## **NHTSA Recall 24V-717**

Brinkley RV REC-2403

**SAFETY CHAINS**

## MODEL Z AIR TRAVEL TRAILER SAFETY CHAIN REPLACEMENT

## Preparation

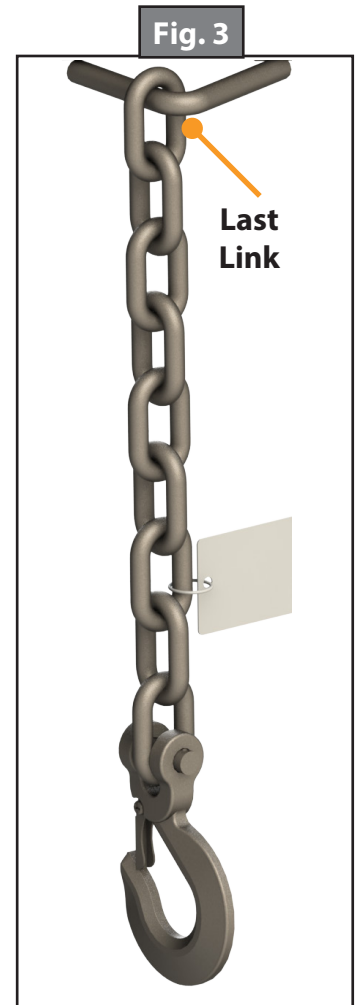
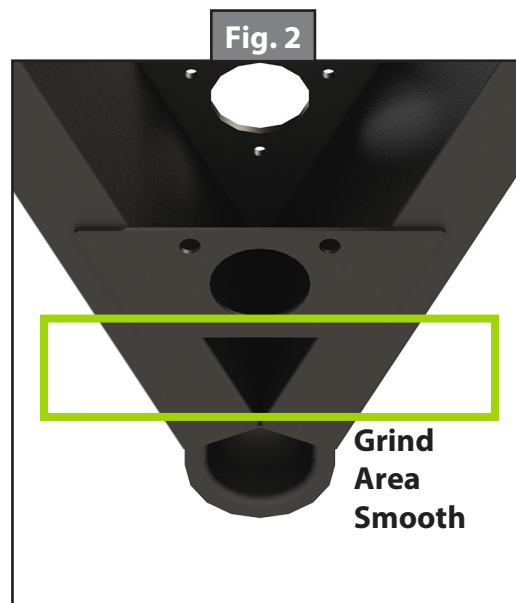
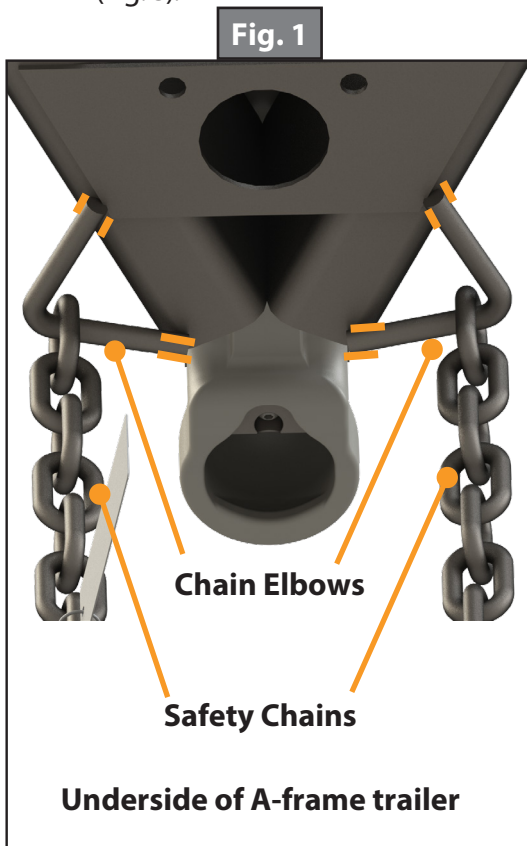
1. Use the appropriate cutting method to remove the existing chain elbows from the underside of the A-frame coupler (Fig.1).
2. The existing safety chains can be set aside with the chain elbow.
3. Use the die grinder and grinding wheel attachment to grind the cut areas smooth (Fig.2).
4. Feed the last link of each of the new safety chains onto the new chain elbows (Fig.3).

**Fig. 4**

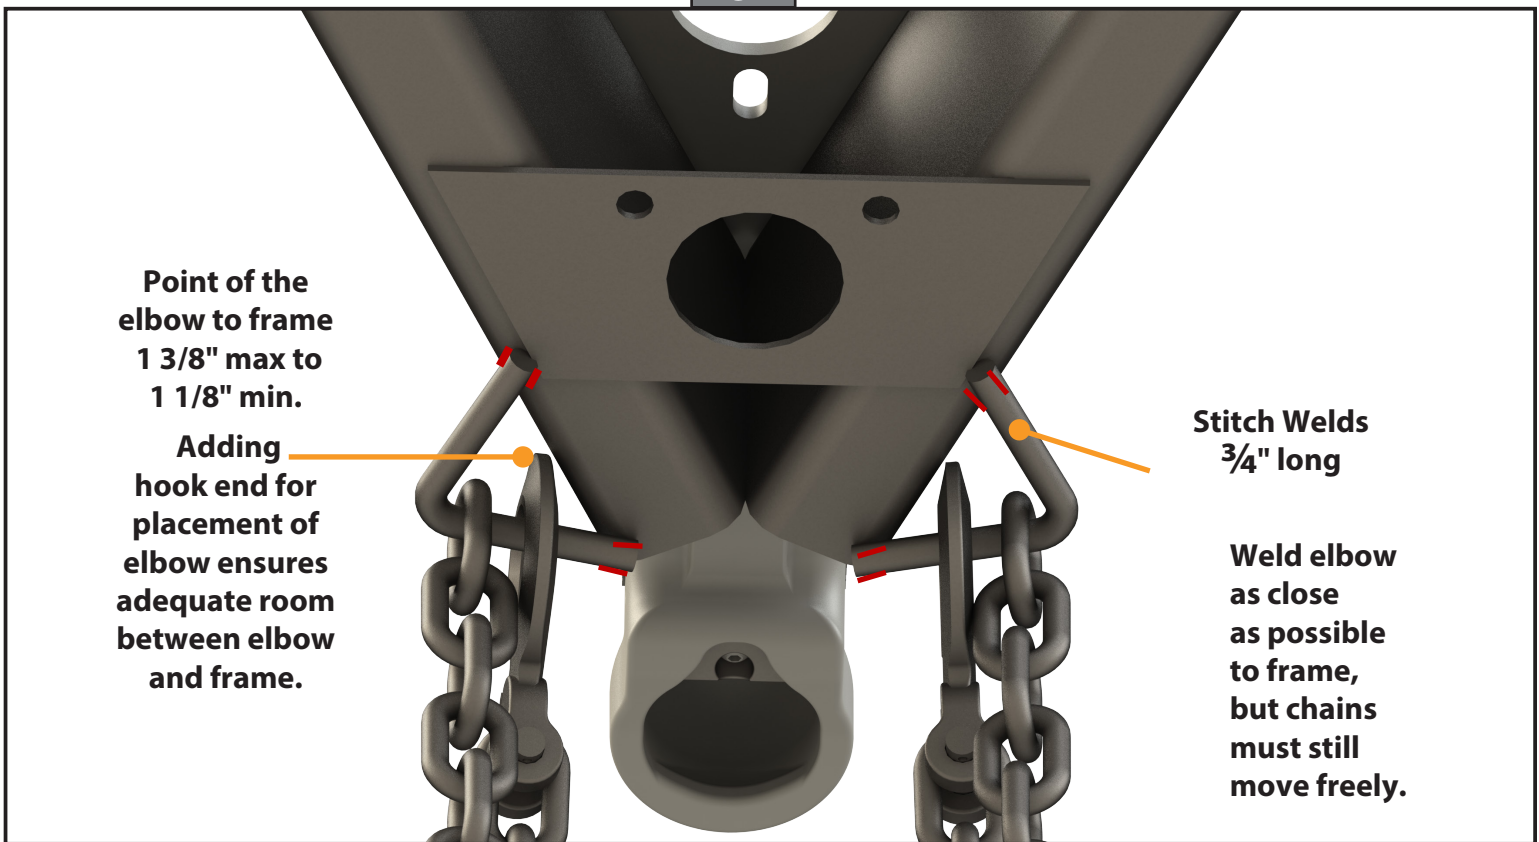
5. Center the chain elbow and safety chain assemblies under the A-frame coupler so that the ends of the chain elbow are touching the ends of the two A-frame tubes (Fig.4). The elbow should be pointing away from the trailer.

6. Include hook end of the chain on the elbow (Fig. 4) during placement to ensure room to use the elbow as an attachment point for hooks when not in use.

7. Make sure that the new safety chains are not pinched between the chain elbow and the A-Frame. The safety chains **MUST** be able to move freely.
8. The bend in the elbows **MUST** measure 1 3/8" maximum to 1 1/8" minimum from the A-frame (Fig.4).

9. Stitch weld each end of the chain elbow to the A-frame tubes (Figs. 4). Make certain to weld both the inside and outside of the chain elbow.
10. Test the movement ability of the safety chains to make sure they are able to move freely.
